**CHANGE OF USE REVIEW**  
**DEVELOPMENT APPLICATION**

ROCKSLIDE BREW PUB  
PATIO DINING EXPANTION  
GENERAL PROJECT REPORT

FILE #COU-95-4.8

TITLE HEADING: Change of Use - Retail to Outdoor Seating for Rockslide Brew Pub

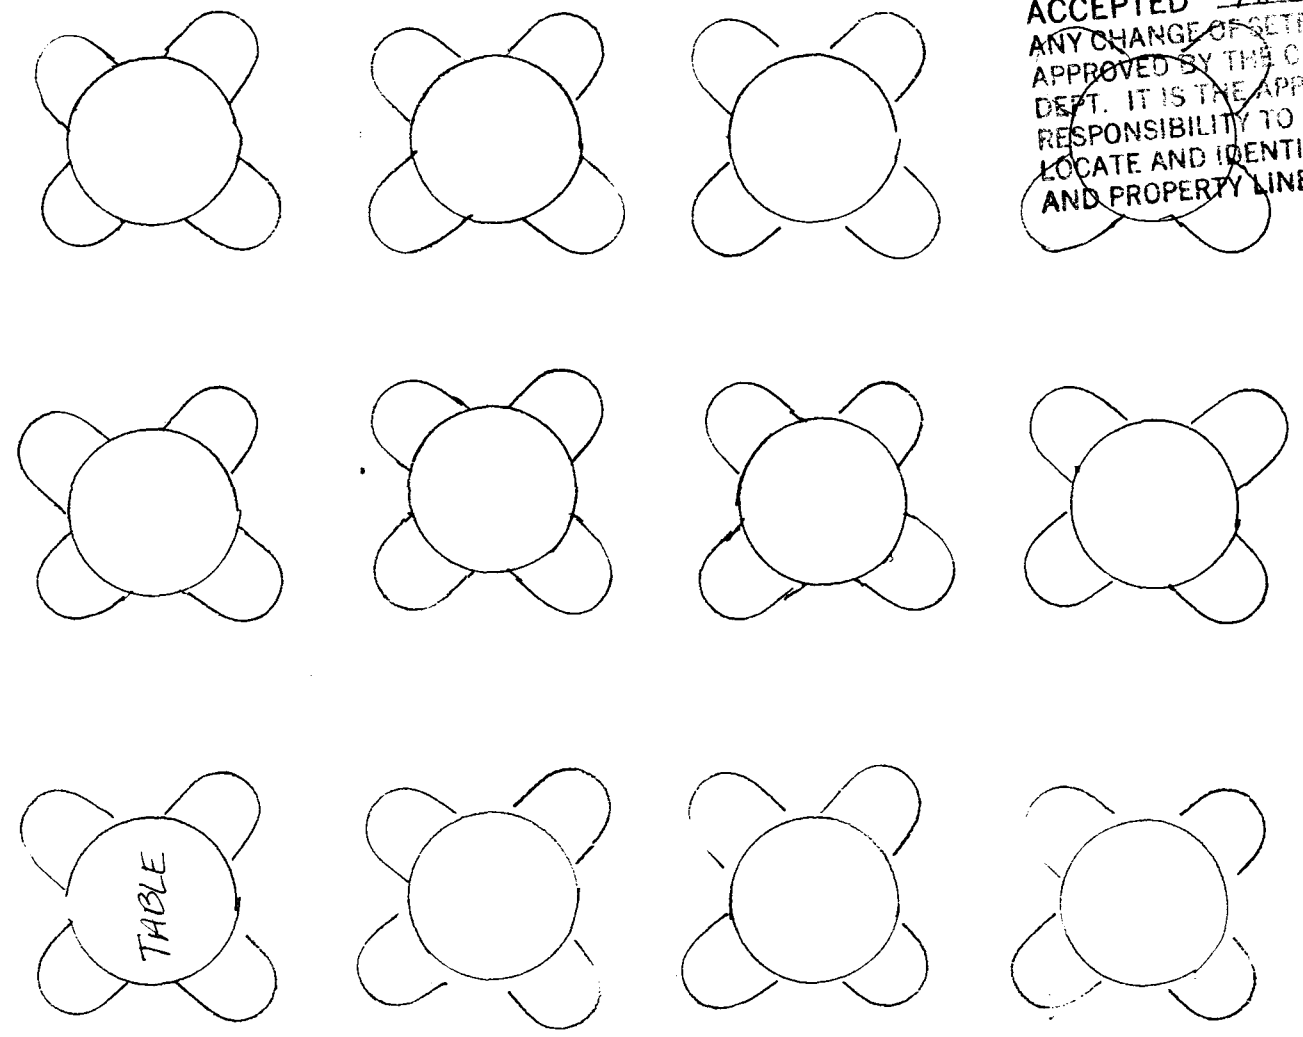
Due to the location of the proposal, I would recommend the petitioner provide lighting in this area even when the business is not open. This will assist police when on patrol as well as discouraging possible burglary attempts in this secluded area.

If occupant load of the patio area exceeds 50, a second exit from the area is required. The square footage of the patio results in an occupant load of 58, while the seating arrangement proposed is for 48. The fenced area with gate on the south side could be arranged as an emergency exit for a required second egress.

The Zoning and Development Code requires one parking space per three seats. The site plan shows 48 seats, thus requiring 16 parking spaces. On September 13, 1995 at 1:30 p.m. the parking lot behind the Rockslide had 95 vehicles parked in the 125 space parking lot. On September 18, 1995 the lot had 101 spaces at 1:15 p.m. This does not include parking spaces along the street or the lot on the northwest corner of 4th Street and Colorado Avenue. Per Section 5-5-1.H.37 there appears to be adequate parking for the proposed outdoor seating.

Where is exit from patio area, other than into the building, for emergencies? See comments from the Fire Department.

We will provide adequate lighting on the walls around the patio.  
We will also put spot lights at the rear by the alley.

There will be a gate through the fence for emergency exit and deliveries to the frame shop.
